**From:** Jerad\_Brockman@oxy.com  
**Sent:** Thursday, March 15, 2012 6:59 AM  
**To:** Warnell, Terry G, EMNRD  
**Subject:** RE: Hobbs Packer Settings  
**Attachments:** SHU COOP 11 Type Log.ppt

Attached is a type log and wellbore diagram for the South Hobbs Unit Coop # 11 API # 30-025-28970.

# South Hobbs Unit COOP #11

## Type Log

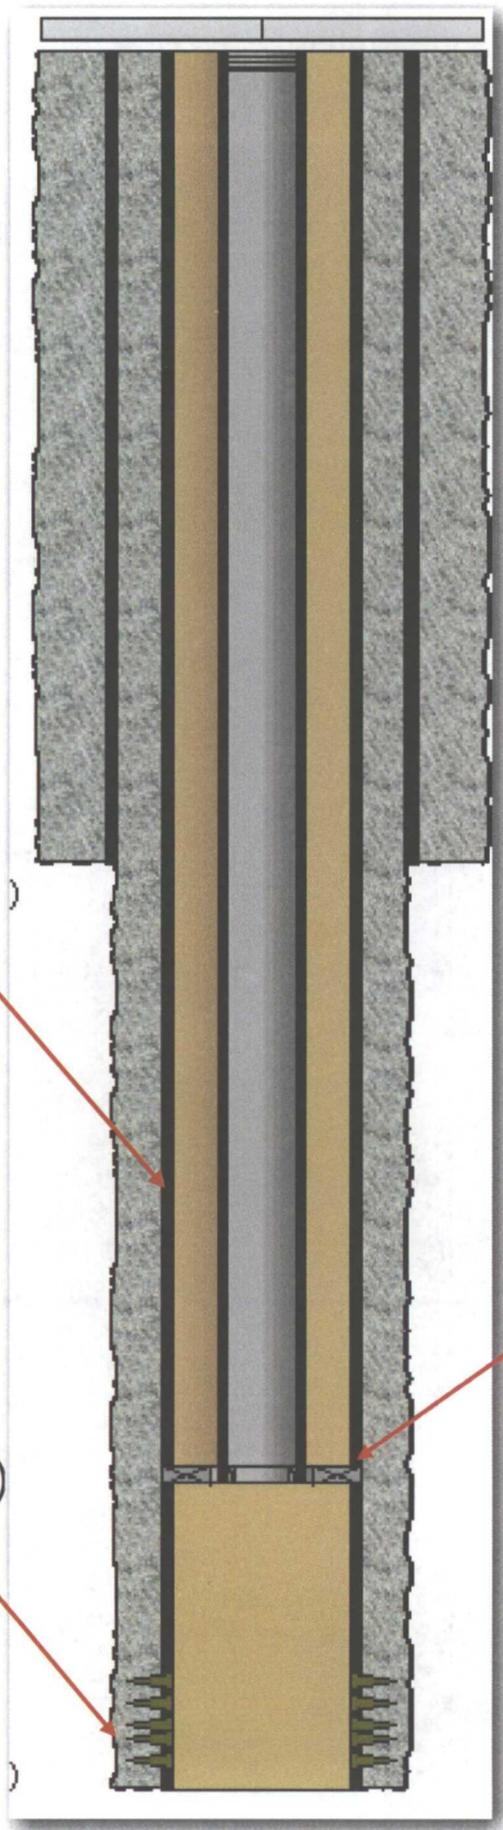
The packer is set at 4128' and the top perf is at 4259' (131 feet in between). The top of the unit in this well is at 3899'. After the previous workover the packer was set at 4135' (July 1990) so we moved it up 7' to get a good seat.

*4259'  
- 4128'  
-----  
131*

*TUI 3899'*
